Subject: Fort Pierce Self Storage - 481 Ohio Avenue – TRC Comments & Conditions

Fort Pierce Planning Department

**RE : Fort Pierce Self Storage Site Plan – 481 Ohio Avenue
TRC No. 21-07000004**

431 Ohio
Avenue.png

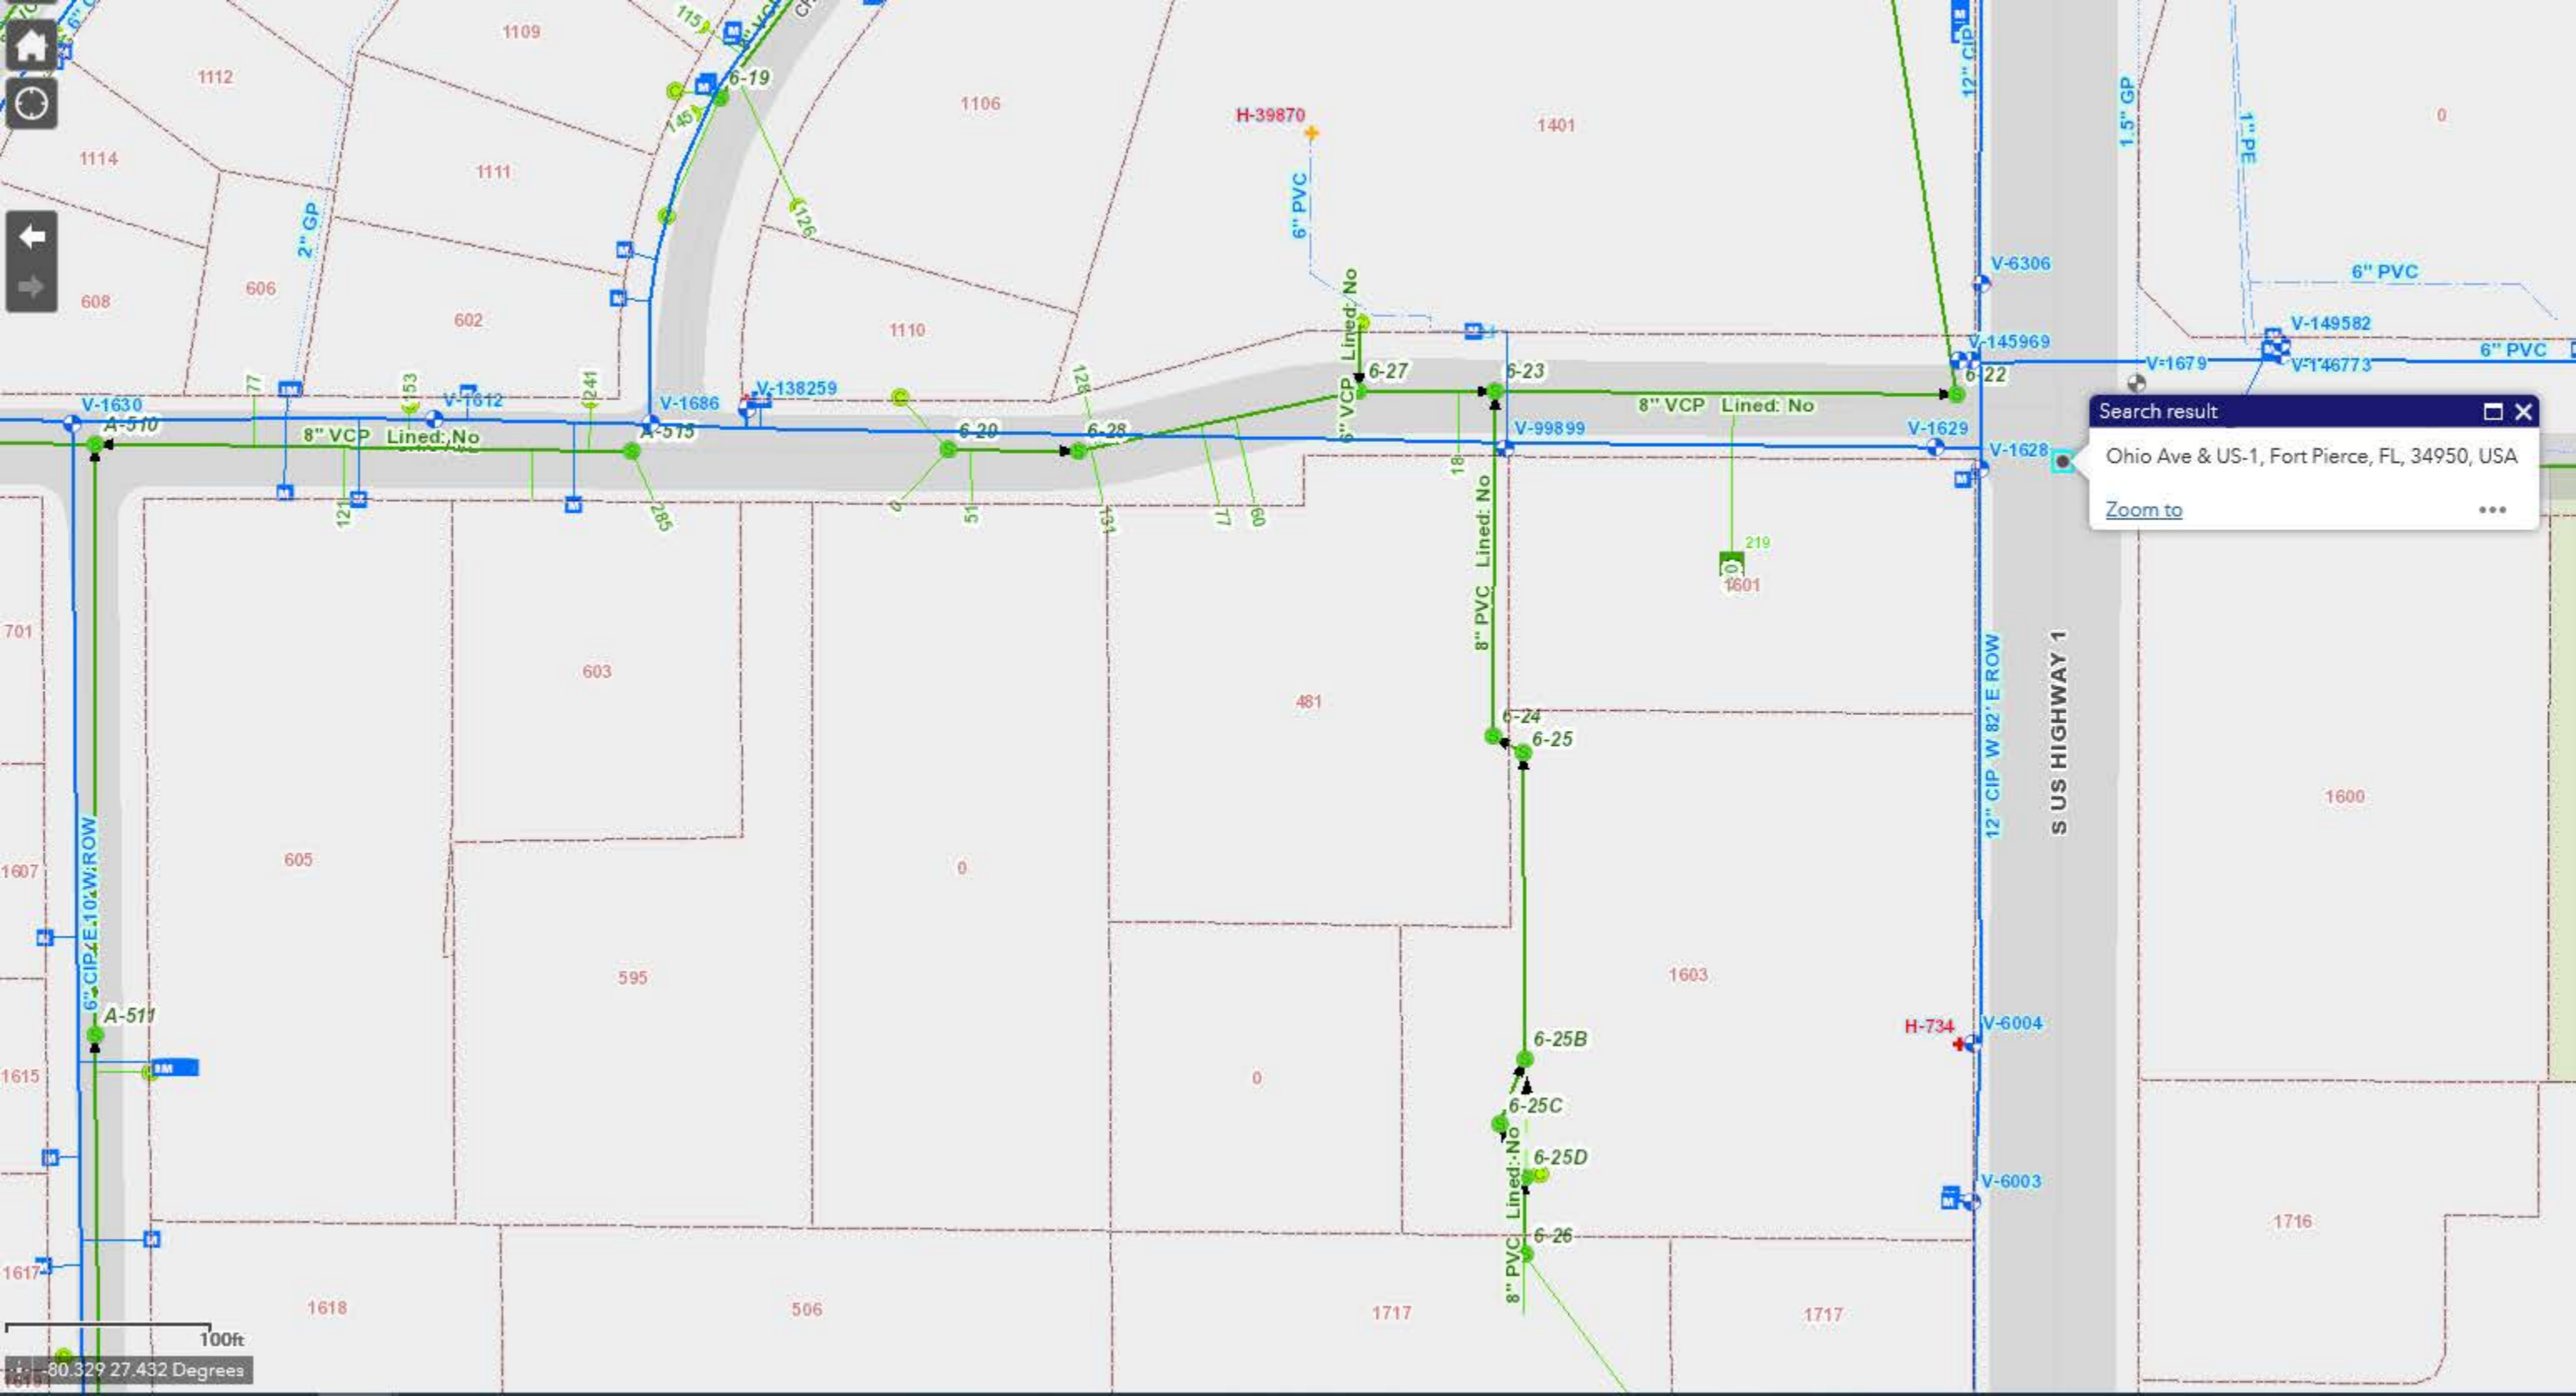
Water and sewer are available should the need arise in the future. There are sewer services to the property that will need to be abandoned. A map showing the existing utilities are attached for your use.
